Pentium® II Xeon™ Processor Specification Update

Release Date: August 1999

Order Number: 243776-015

The Pentium® II Xeon™ processor may contain design defects or errors known as errata which may cause the product to deviate from published specifications. Current characterized errata are documented in this Specification Update.

Figure 1. An Example of Microcontroller Driven Thermal Management

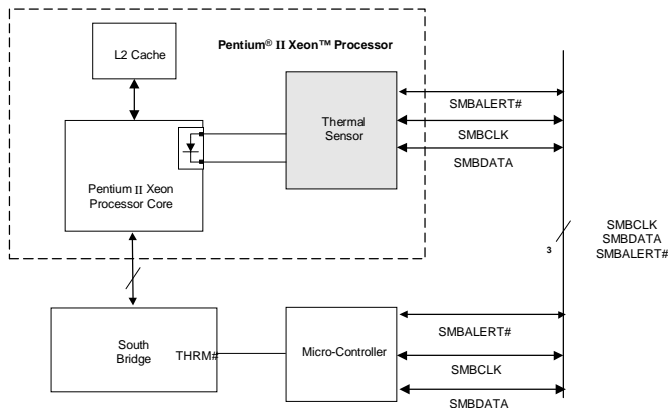
D30. Thermal Sensor May Assert SMBALERT# Incorrectly

PROBLEM: The Pentium II Xeon processor has a thermal sensor that monitors the processor core's temperature. The thermal sensor asserts SMBALERT# if the processor temperature exceeds the temperature limits set in the Alarm Threshold Registers (T_{HIGH} , T_{LOW}). It also sets the corresponding Status Register bits to identify the cause of the interrupt. Figure 1 gives one example of the how the SMBALERT# signal could be used in a system.

Under the conditions described below, the thermal sensor incorrectly generates the SMBALERT# interrupt. *All* of the following conditions must be met to trigger a false interrupt:

WORKAROUND: Three different (mutually exclusive) workarounds are possible:

1. Before servicing an interrupt from the thermal sensor, read and compare the processor thermal reading with the threshold limits (T_{HIGH} or T_{LOW}). Figures 2 and 3 provide basic flowcharts for the implementation of this workaround in an interrupt driven system.
2. If the firmware implemented polls the Status Register only, then before taking any action, re-read the temperature register and do a comparison with the alarm threshold limits (T_{HIGH} or T_{LOW}) to determine if the value is actually still within the temperature window.
3. Use a temperature polling scheme to monitor the processor temperature.
